UCH COMPRESSION PROJECT

Tender Enquiry No. PROC-FC/CB/PROJ/UCH (COM)-5155/2021

Pre-Bid Clarification-05

COVER DRAWING FOR DIESEL STORAGE TANK 800-TK101(452 M³)

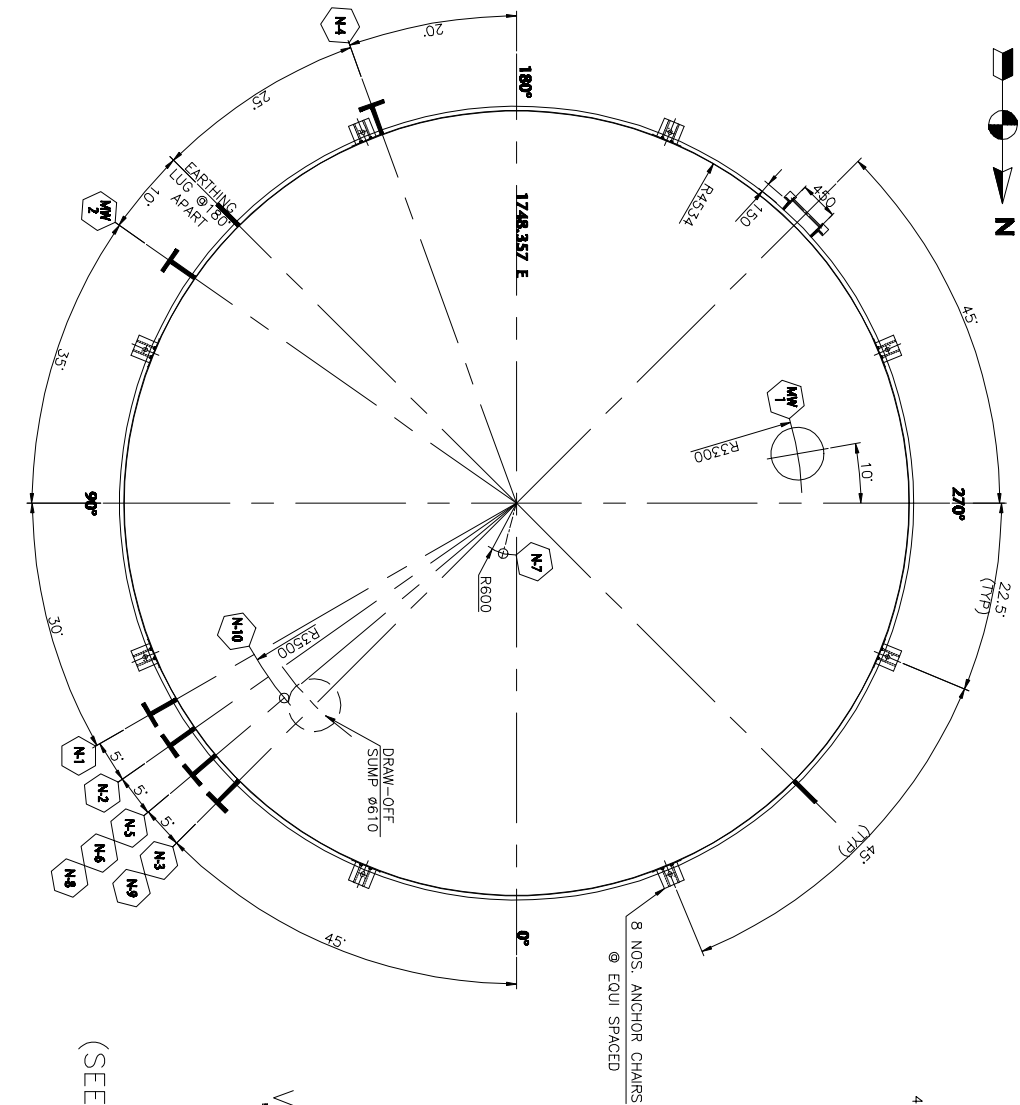
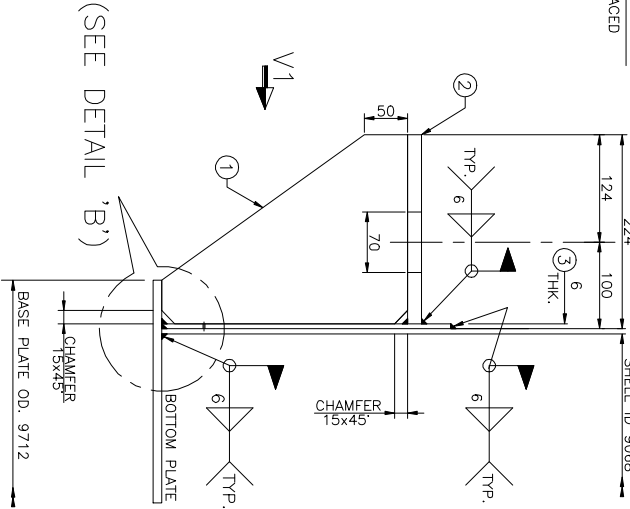
14	Bidder understand that Given wellheads are controlled through existing system and No modification shall be made in controlling of wellheads after addition of hydrate inhibitor packages.	The I/Os of Hydrate Injection skid as mentioned in project I/O list shall interface with respective wellhead RTU (Control System) and accordingly wellhead RTU shall be modified (hardware/software). Further, bidder to adhere with tender requirements.
15	Bidder understand that relocation of diesel tank shall only include relocation of tanks and pumps. Please clarify the scope of piping at other end including size of piping, class, and lengths.	Please refer Sec-9.0 of SEC-III Scope of Work. Also, piping plan is attached,. Furthermore, any missing information shall be gathered from site by bidder itself.
16	Please confirm cable sizes of Diesel pumps and other cables included in relocation.	Please review relocation scope carefully. Cables shall not be dismantled, only cables shall be unterminated from both sides and covered with caps and existing cables shall remain buried in trenches. However, existing location/plot shall be made free for installation of centrifugal compressor as marked in the plot plan. Further, new cables shall be sized and supplied for diesel pumps as per new location.
